AMENDMENTS TO THE DRAWINGS

Attached hereto are two (2) sheets of corrected formal drawings that comply with the provisions of 37 C.F.R. § 1.84. The corrected formal drawings incorporate the following drawing changes:

Fig. 1

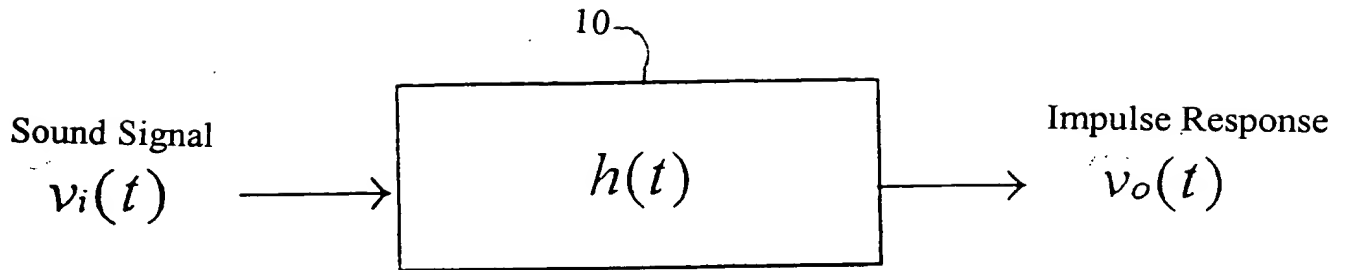
Figs. 1 and 13 reference numerals and labels have been added.
